Access Compliance Report Public Rights-of-Way (Curb Ramps)

Main Street: WELBE_CIR		Cross Street: MAIN_ST		Location:	SW
ADA ID: RPRK211101133424	Ramp Type: Type 4 - Parallel	Initial Pass/Fail: Fail	Overall Compliance: No	Severity Score:	16

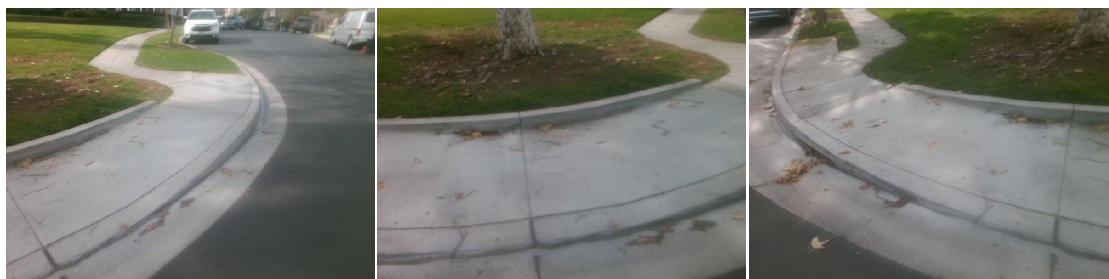
Compliance	Description	Data	Compliance	Description	Data
N/A	Ramp Length LT (in)	114	N/A	Ramp Length RT (in)	114
Yes	Ramp Width LT (in)	54	Yes	Ramp Width RT (in)	54
Yes	Ramp Run Slope LT (%)	1.5	No	Ramp Run Slope RT (%)	9.3
No	Ramp Cross Slope LT (%)	4.9	No	Ramp Cross Slope RT (%)	2.3
N/A	Landing Present	N/A	N/A	DWS Provided	N/A
N/A	Landing Length (in)	N/A	N/A	DWS Contrast	N/A
N/A	Landing Width (in)	N/A	N/A	DWS Length (in)	N/A
N/A	Landing Run Slope (%)	N/A	N/A	DWS Full Width	N/A
N/A	Landing Cross Slope (%)	N/A		DWS Offset Type	N/A
N/A	Landing Movement Obstructed?	N/A	N/A	DWS Offset Left (in)	N/A
	Landing Movement Type	N/A	N/A	DWS Offset Right (in)	N/A
N/A	Landing Shared	N/A			
N/A	Clear Space	Yes			
N/A	Clear Space To Crosswalk (in)	N/A			
N/A	Marked Crosswalk 1	No	N/A	Marked Crosswalk 2	No
	Crossing 1 Direction	E		Crossing 2 Direction	N
	Marked Crosswalk 1 Width (in)	N/A		Marked Crosswalk 2 Width (in)	N/A

N/A	Ramp Inside Crosswalk 1	N/A	N/A	Ramp Inside Crosswalk 2	N/A
	Crossing 1 Slope (%)	0.9		Crossing 2 Slope (%)	0.8
	Crossing 1 Cross Slope (%)	2		Crossing 2 Cross Slope (%)	2.9
N/A	Gutter Ponding	N/A	N/A	Curb Slope	15.9
Yes	Gutter Lip Height (in)	0		Road Run Slope (%)	2.8
N/A	Gutter Run Slope (%)	N/A		Road Cross Slope (%)	2.1
N/A	Gutter Cross Slope (%)	N/A	No	Perpendicular Joint Present	No
Yes	Overall Surface Condition	Acceptable			
	Cross Gutter Present?	No		Spandrel Present?	No
	Replace Cross Gutter?	N/A		Replace Spandrel?	N/A

Remove & Replace Curb Ramp With Two New Directional Ramps or Equivalent.
